Appendix J

Lois Drive & 32nd Ave Pathway Mailing Area: 354 Parcels

LOIS DRIVE & 32ND AVENUE PATHWAY

Draft Design Study Report

LOIS DRIVE – ALTERNATIVE 2, WITH INTERSECTION #2

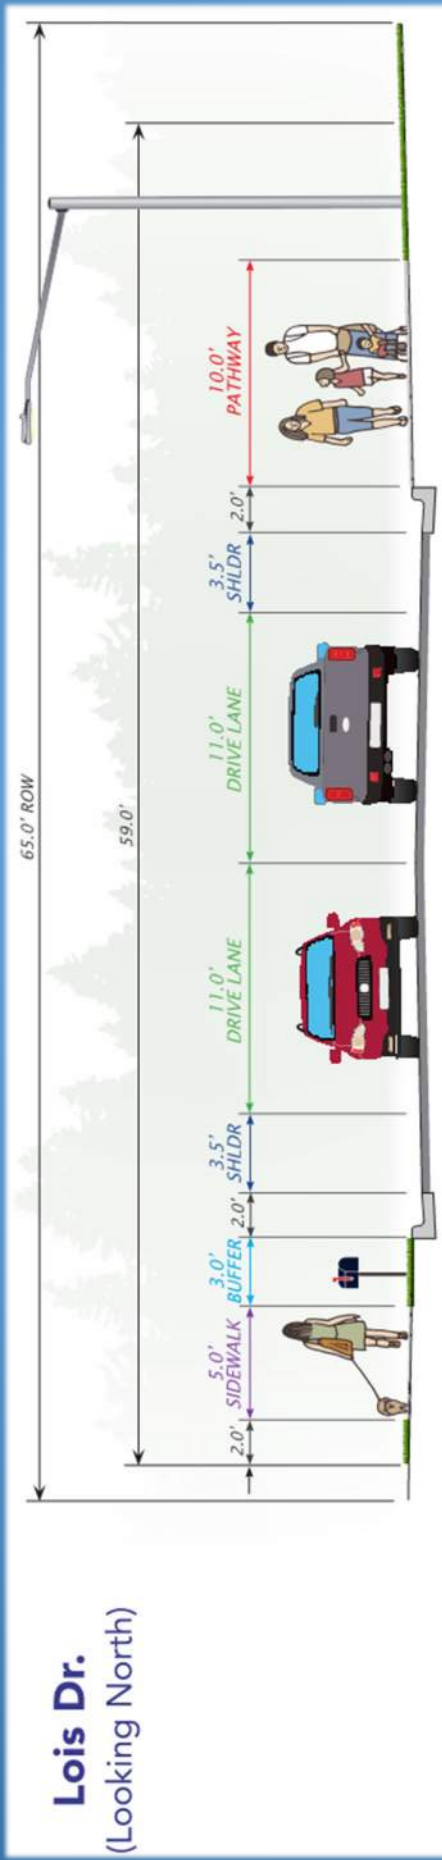
How would the roundabout work with alternative 2?	That would have to be looked at further in design. We did not analyze those, I'm assuming you mean roundabout with roadway 2. It would work, we just didn't show it that way. Any of these intersections can be interchanged with any of the roadway alternatives. It would work, it would just look different.
Remind electric utilities that we've all been paying undergrounding fees for years!	N/A
There are no ROW funds expected, right?	Correct. The next process is one we have a preferred alternative which would include expected costs for acquisition of right of way. Depending on those costs, right of way funding would either come separately if they are significant costs; for example, if they include relocation costs. Those are often funded separately ahead of the project. If they're minor costs, drainage easement, slope easement, etc. those are normally funded with the project. There are currently no design or ROW or construction funding.

<p>Are these alternatives going to be posted on the site? Or how do we get to see?</p>	<p>All questions and comments have been documented and are part of the project record. You can email questions and comments to project team. All project documents and materials will be on the project website. There will also be a self-guided virtual meeting so you can review the alternatives again to peruse and provide written comments.</p>
<p>I like alternative 2 with a roundabout!</p>	<p>N/A</p>

32ND AVENUE – ALTERNATIVE 4

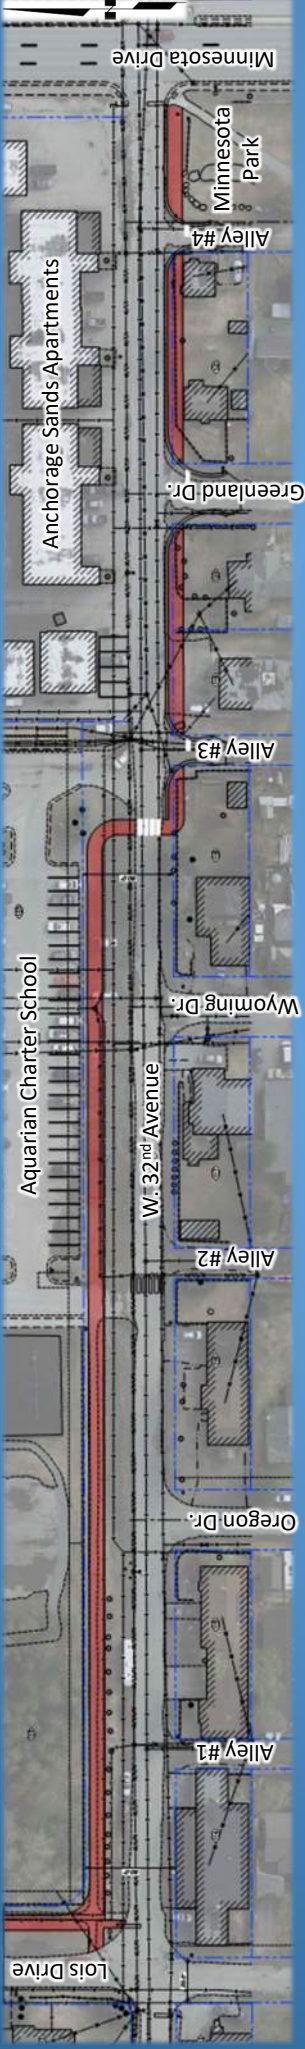
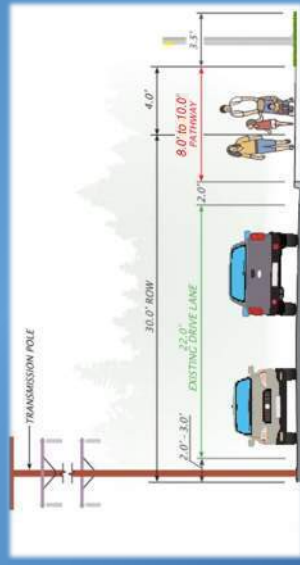
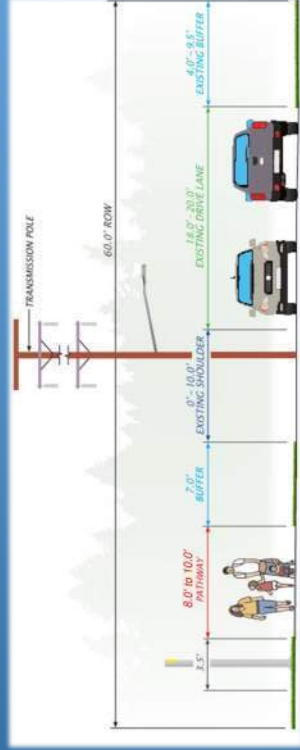
I support the Lois Drive Alternative 4 (pathway only) project as a Phase 1 implementation. I think the best way forward is to use design monies to create a phased plan which starts with a continuous pathway on the east side of Lois Drive. Phase II should be the Lois/West 32nd intersection (including the roundabout idea). I never would have thought of that. It's a good idea. Phase III should be 32nd Avenue on-street parking and pathway improvements. Phase IV needs to consider PM&E's important roadbed and utility upgrades on Lois Drive north from the 32nd Avenue roundabout.	Email	Design Study Report
I like Alternative 2 with the round a bout!	Virtual Open House	Design Study Report
Other		
Change the name from Lois Drive to Lois Lane	Open House #1, Scroll	Concept Report
There is new development behind parcel 116	Open House #1, Scroll	Concept Report
Resident asked about past design studies related to Lois Dr. (during DOT ownership, not since MOA transfer)	Spenard Community Council	Concept Report

I support the Lois Drive Alternative 4 (pathway only) project as a Phase 1 implementation. I agree we need to consider how to meet all the needs identified by PM&E, Muni Traffic, ASD and the local stakeholders. I think the best way forward is to use design monies to create a phased plan which starts with a continuous pathway on the east side of Lois Drive. Phase II should be the Lois/West 32nd intersection (including the roundabout idea). I never would have thought of that. It's a good idea. Phase III should be 32nd Avenue on-street parking and pathway improvements. Phase IV needs to consider PM&E's important roadbed and utility upgrades on Lois Drive north from the 32nd Avenue roundabout.
